SERVICE BULLETIN

No.606

Piper Aircraft Corporation

Stabilator Assembly Lower Surface Rivet and Rib Attachment Inspection

BOTTOM VIEW OF LEFT STABILATOR SHOWN - RIGHT STABILATOR OPPOSITE

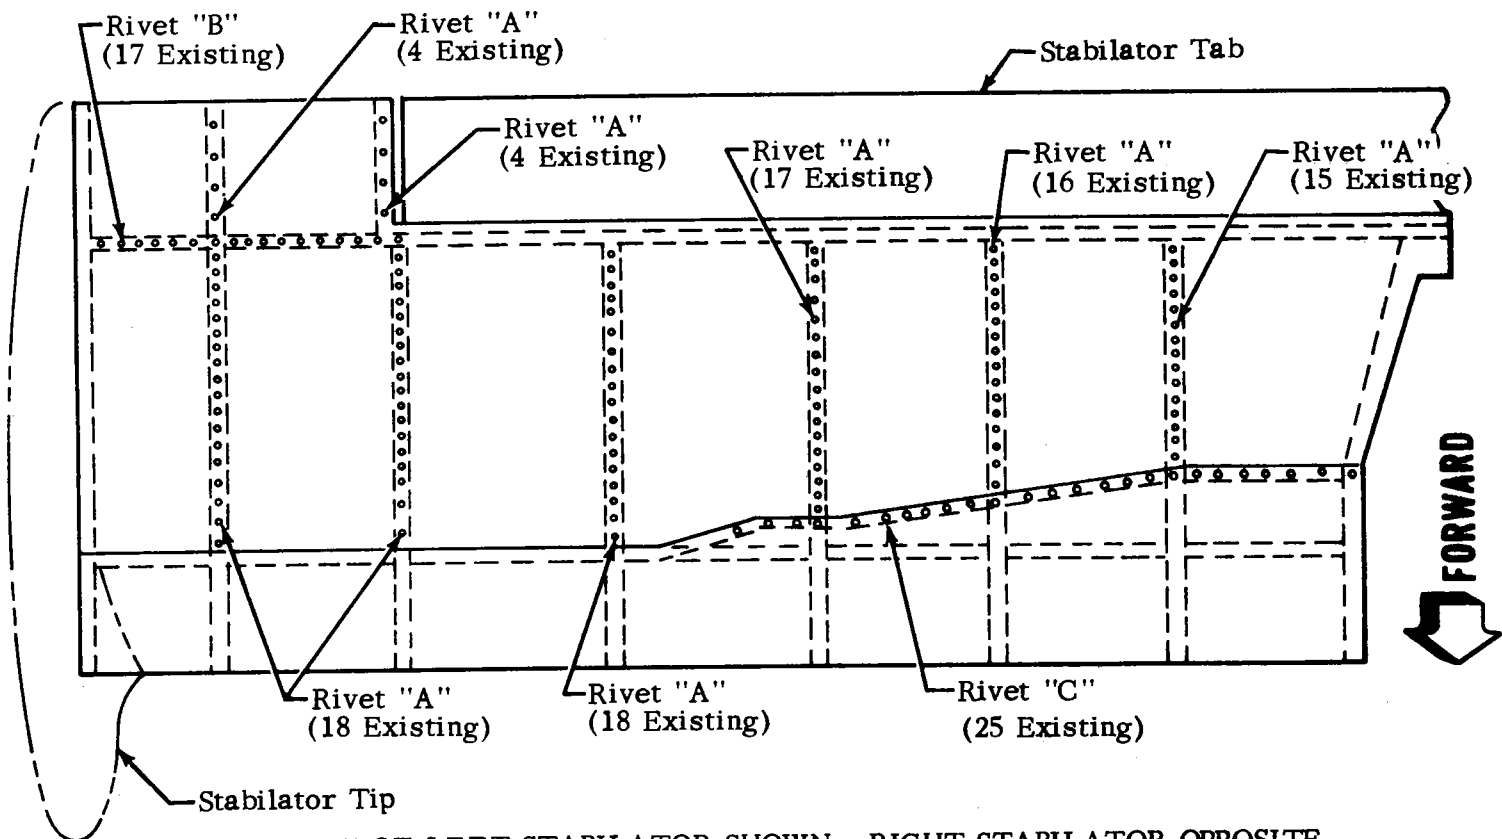
- A. Inspect the lower surface of the left and right stabilator assemblies for evidence of loose blind rivets. Refer to sketch for location of existing blind rivets. (Loose rivets may be noted by the presence of dark streaks downstream of the rivet heads.)

- B. Remove stabilator tip. With a mirror and a light attached to long rods, inspect the bottom flanges of all ribs for evidence of cracks.
 1. If cracks are found, replace the stabilator assembly with a new assembly.

2. If loose rivets are found, they must be replaced with NAS1738B-4-1, or NAS1738B-4-2, or NAS1738B-4-3 cherry lock rivets. (see sketch for location)
 3. If no cracks are found, and loose rivets are replaced, the stabilator tip may be reinstalled and the aircraft returned to service. THIS INSPECTION IS REQUIRED EVERY 100 HOURS OF OPERATION.

4. If it is desired to relieve the requirement for the 100 hour recurring inspection, install additional cherry lock rivets (see sketch & rivet chart) mid spaced between the existing blind rivets in the ribs and rear spar on the bottom surface of the stabilator. (The new cherry lock rivets must be installed between all existing blind rivets shown as Rivets "A" & "B" on above sketch). Reinstall stabilator tip and rebalance stabilator per the Aztec Service Manual.

RIVET	CHERRY LOCK	PIPER P/N
A	NAS1738B-4-1	522 881
B	NAS1738B-4-2	522 882
C	NAS1738B-4-3	522 883
